## ADDENDUM NO. 1

**Sault Ste. Marie Public Schools  
Middle School Structural Roof  
Repairs and Roof Replacement  
Sault Ste. Marie, Michigan**

ADDENDUM NO. 1 is issued April 11, 2025, to clarify, modify, and/or change the original plans and specifications issued by UP Engineers and Architects. This ADDENDUM NO. 1 is hereby made part of the Contract Documents for the contract noted below.

S105

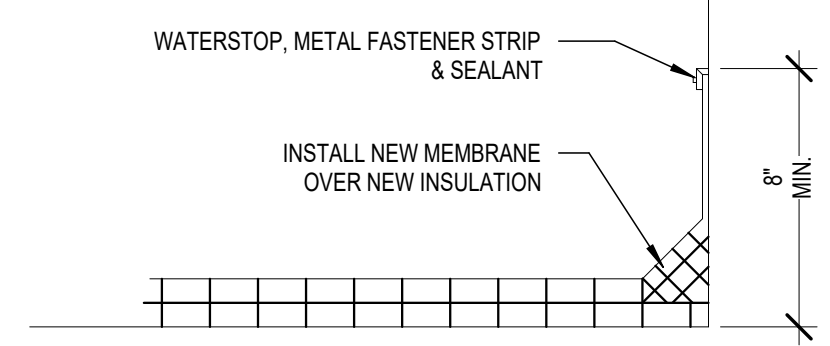
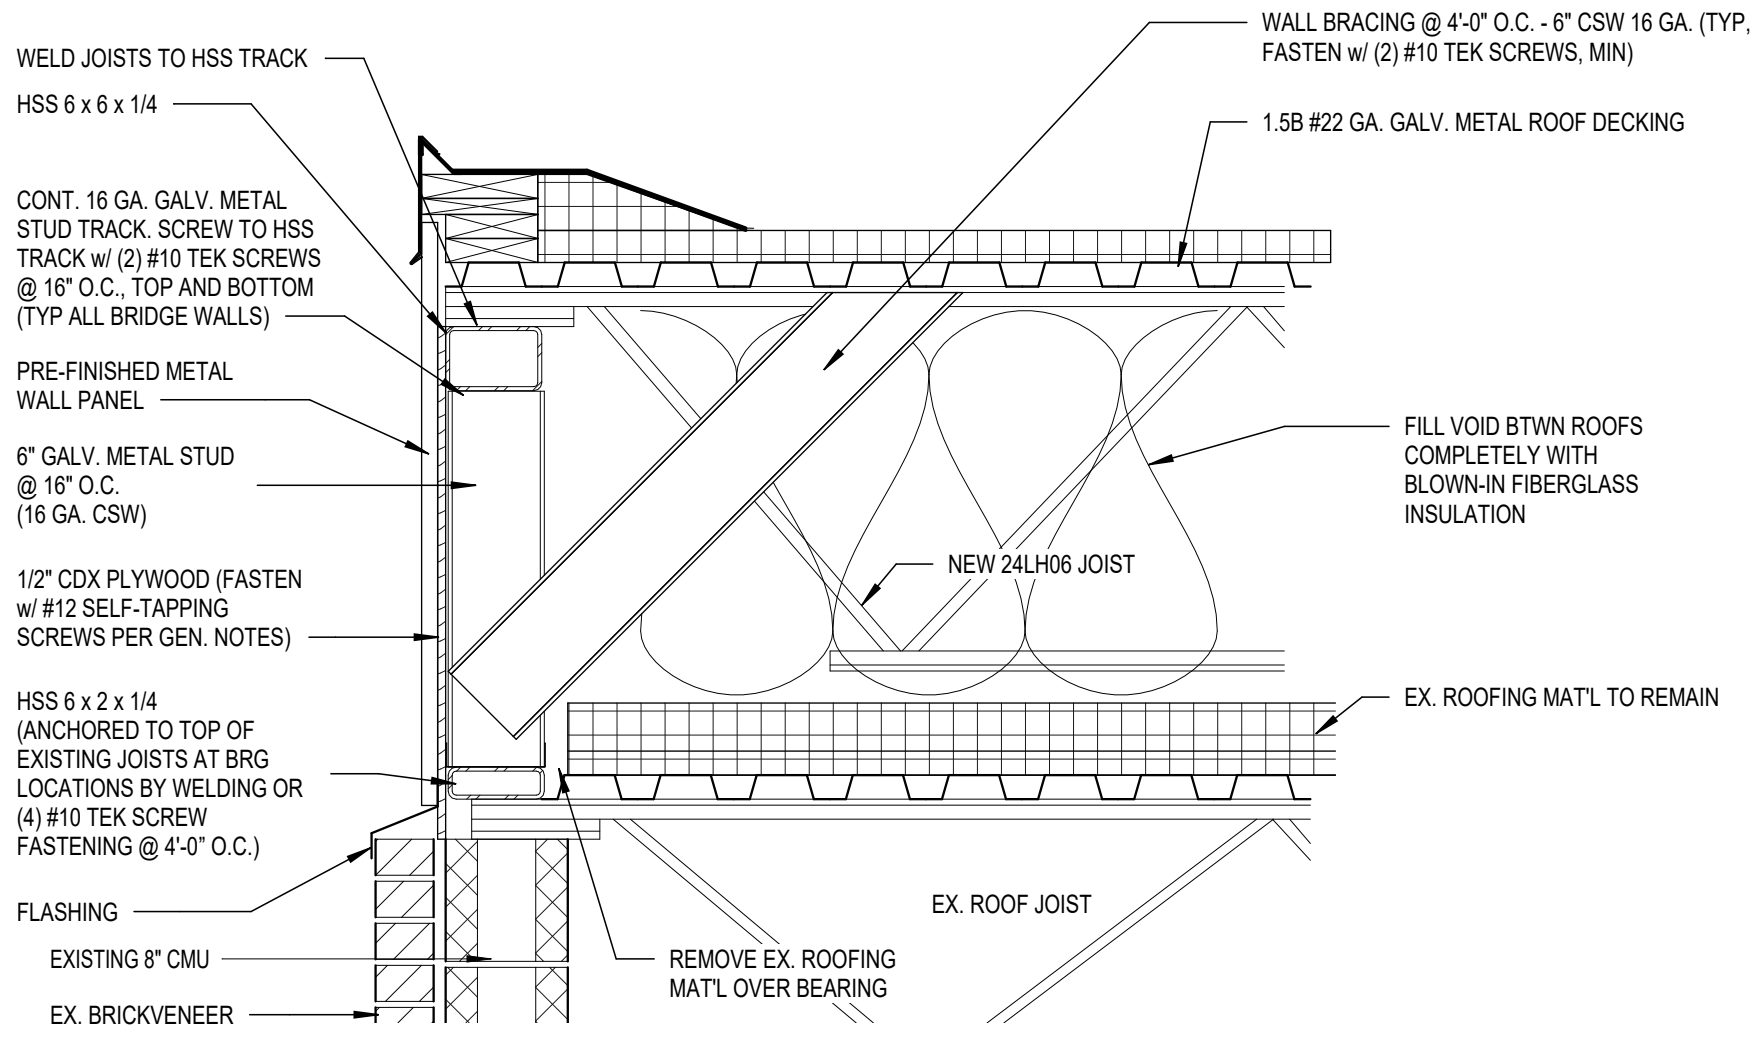
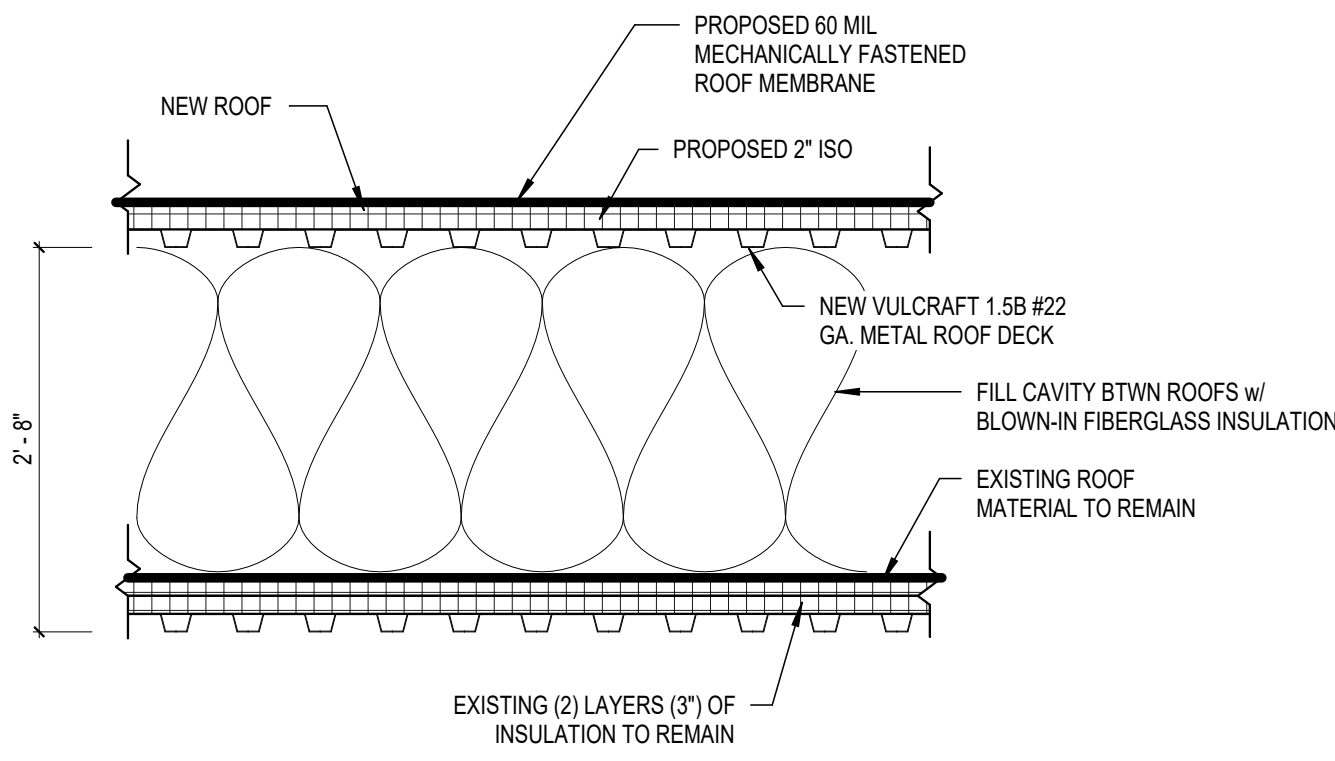
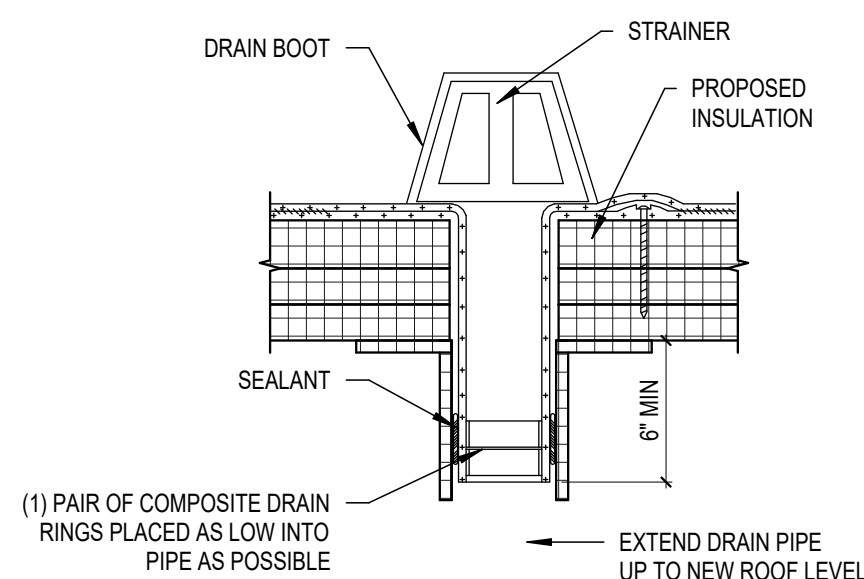
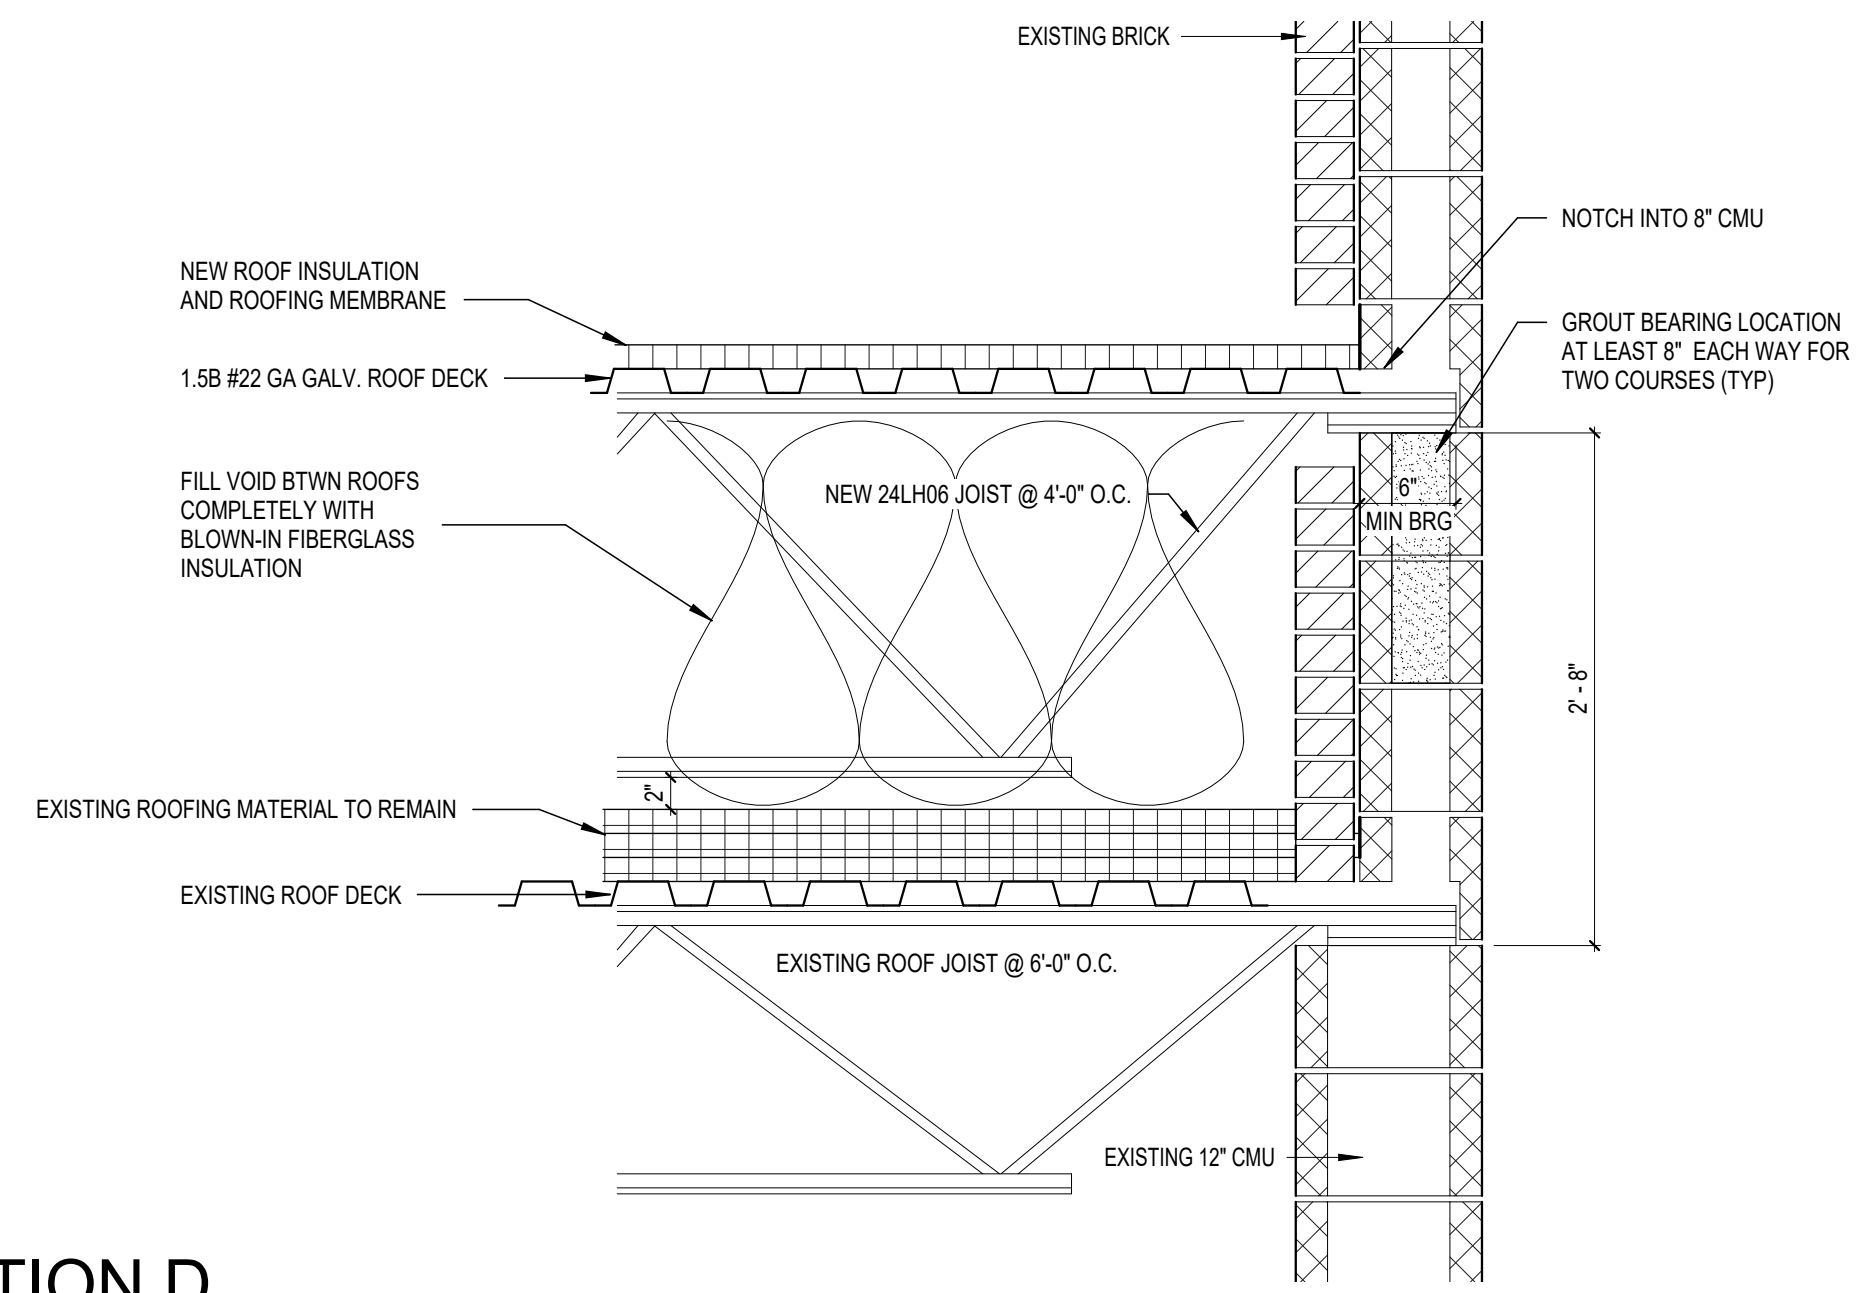
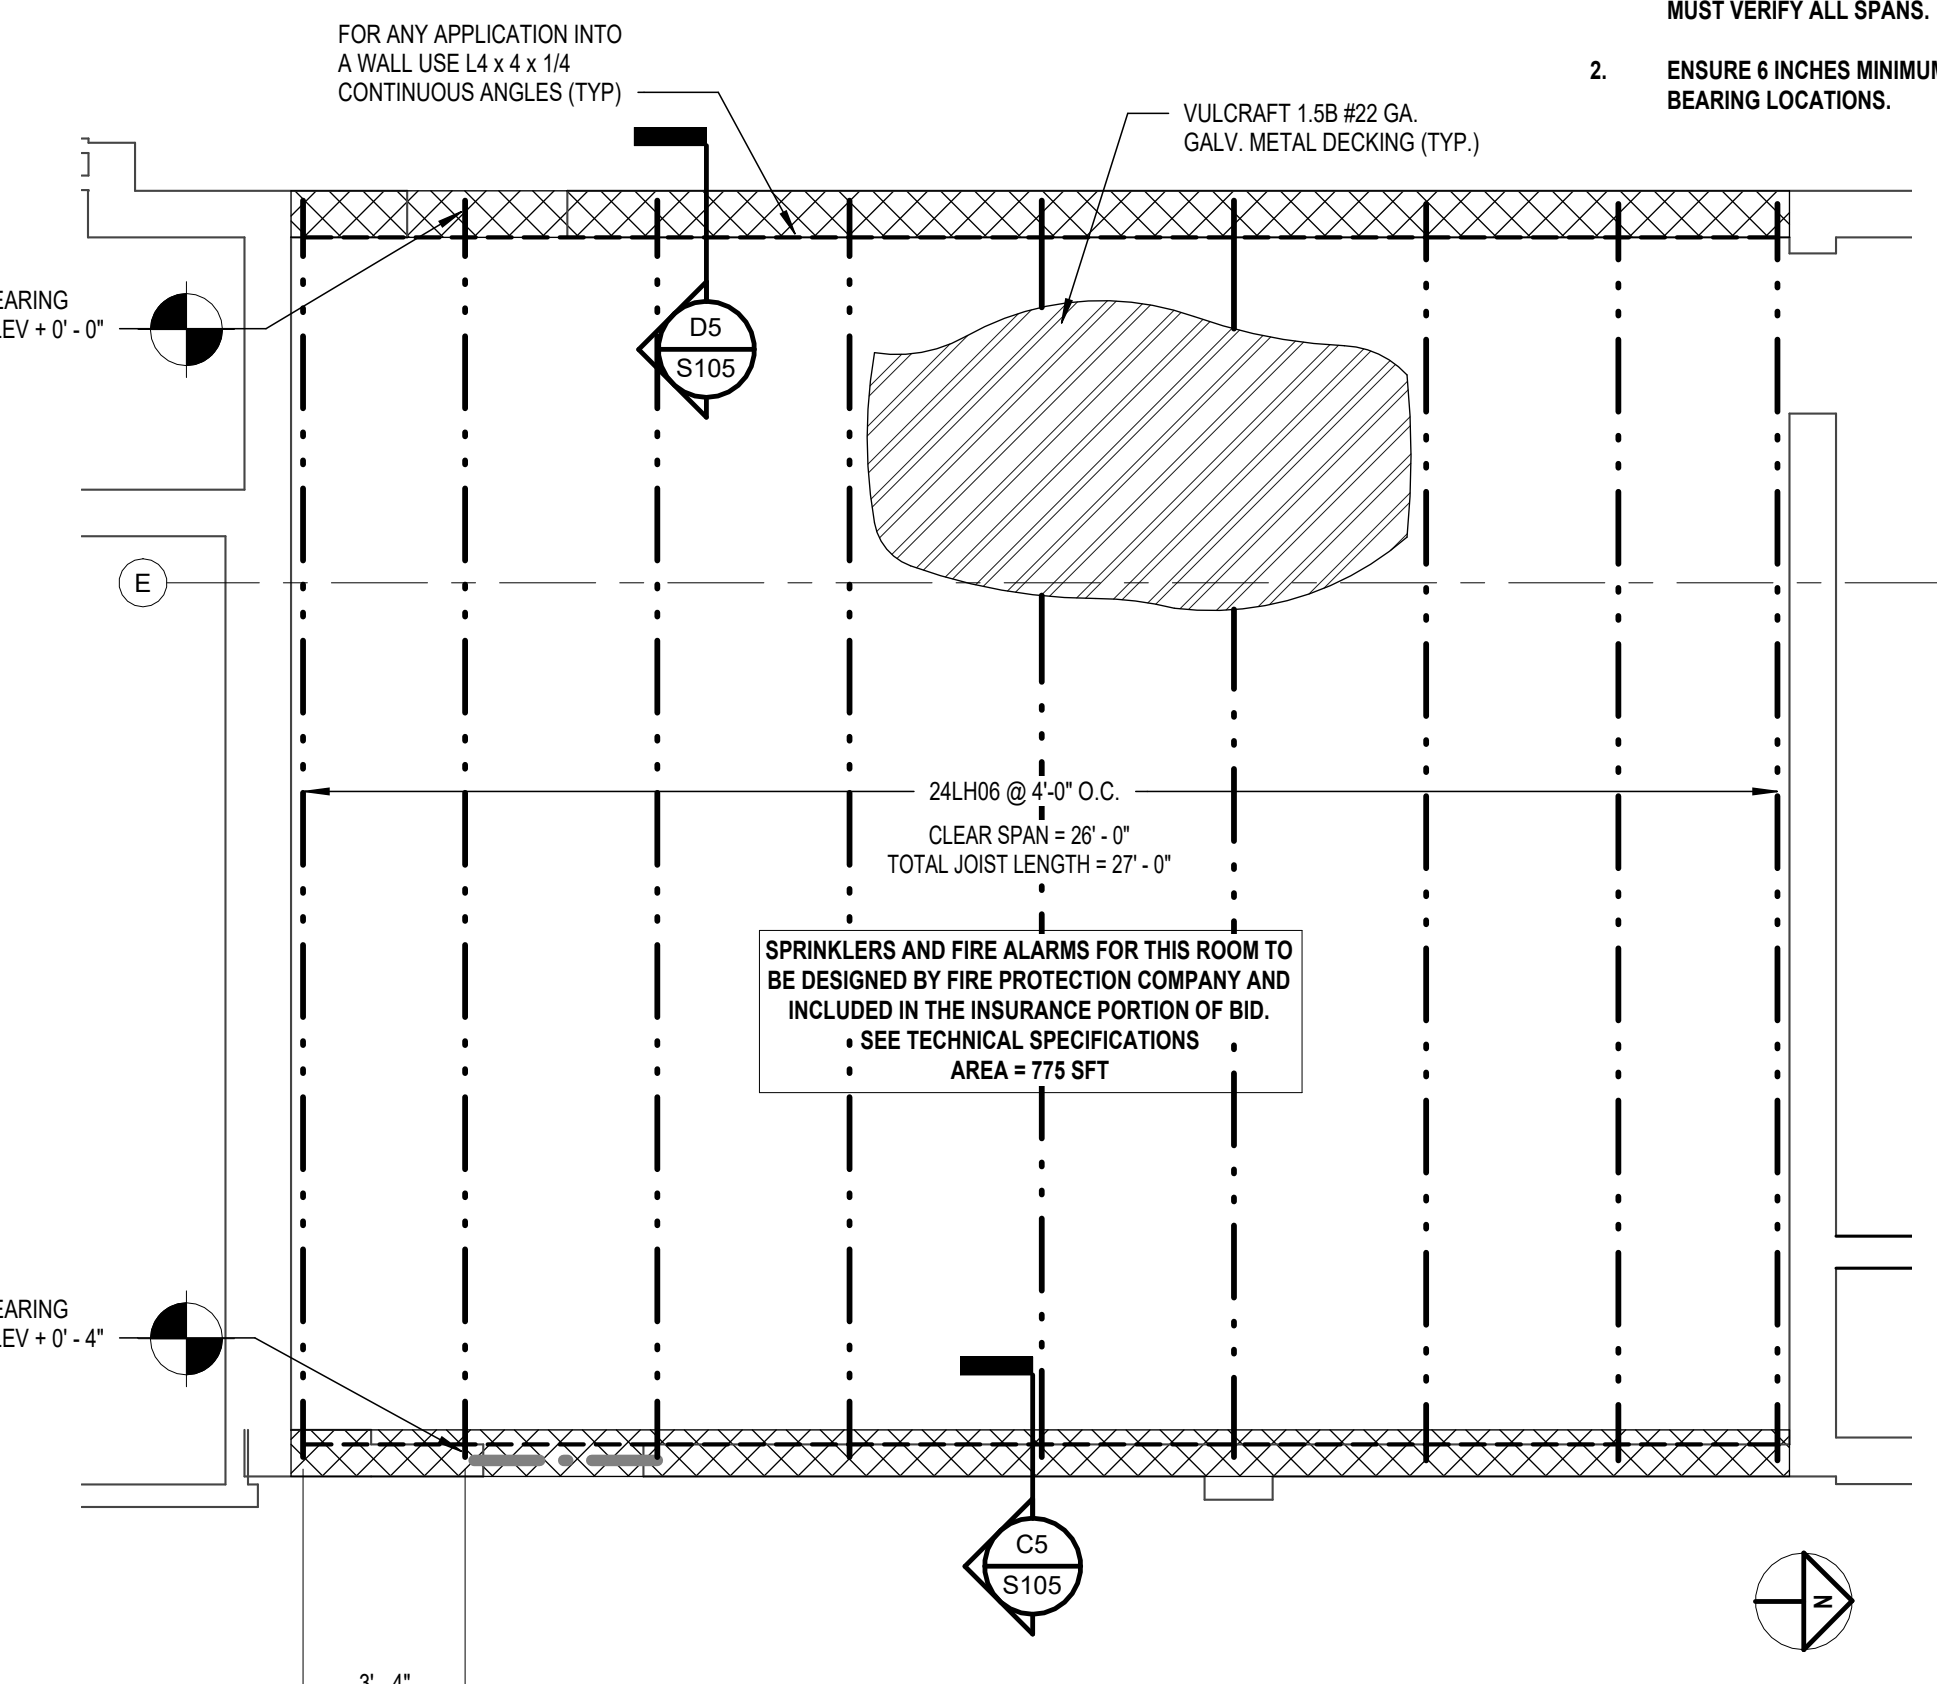
5. See **attached** revised structural details.
  - a. Metal panel at vertical roof extensions.
  - b. Treated plywood on parapet walls.
  - c. Cuts through new beams.
  - d. Denote bearing walls.

- NOTES:
- RAISE ALL VENTS, MECHANICAL EQUIPMENT, ROOF DRAINS, ETC. UP TO NEW ROOF ELEVATION.
  - FILL VOID BETWEEN PROPOSED NEW ROOF AND EXISTING ROOF COMPLETELY WITH BLOWN-IN FIBERGLASS INSULATION.
  - METAL WALL PANELS TO BE MINIMUM 24 GA. THICK PAINTED STEEL; 5+ YEAR WARRANTY; MANUFACTURER: METL SPAN, PROFILE: CS-260, COLOR: "REGAL BLUE".
